Service
Service
Service

HR7759
HR7761
HR7762
RI7761
RI7762

Philips Consumer Life Style

Service Manual

The new HDMT Motor U8916.

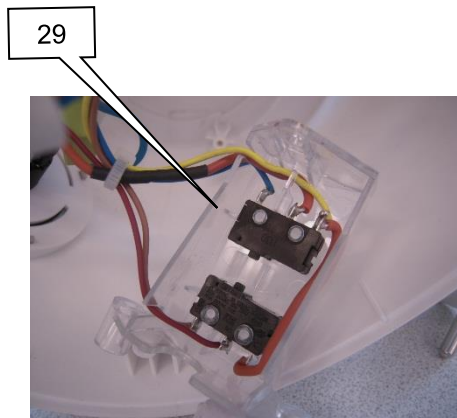
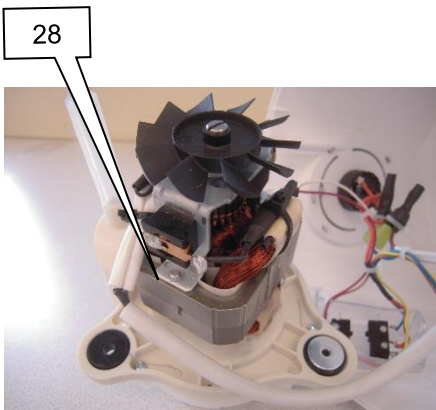
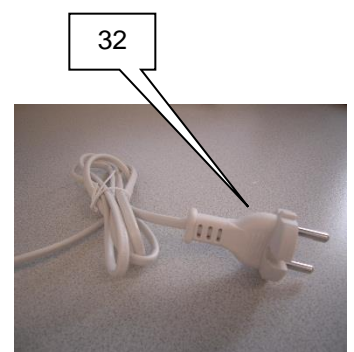
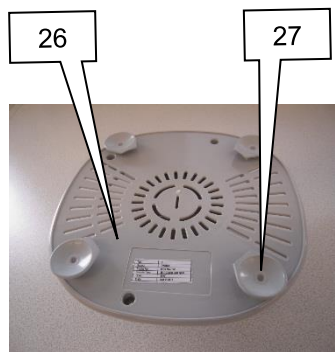
HDMT Motor Phase in Plan(CP1407)

HDMT motors phase in plan

10. Change the part of Pos.28 from old motor set 12NC#996510066409 to new 12NC# 996510073773 except BR base on CP1407 instruction.
For the motor & bottom matching issue, S&C SDA_111102 was created. --- WK1532
